PRODUCT UPDATE

Number: #127H
By: Applications Engineering Dept.
Date: November 14, 2013

Revised LEMO Elbow Plugs (00, B, S, K & E)
FHG.1B.3##.xxxxxx changes to FPG.1B.30#.xxxxxx
(This change includes all keyways)

LEGACY **NEW**

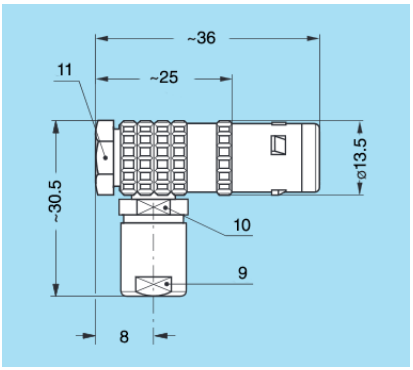
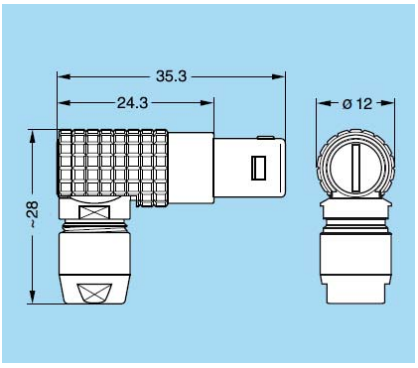
Legacy FHG.1B.3##.xxxxxx	New FPG.1B.3##.xxxxxx

- Shorter overall length 36.0mm to 35.3mm
- Smaller body diameter 13.5mm to 12mm
- Same receptacle compatibility as FHG.0B.30#.xxxxxx
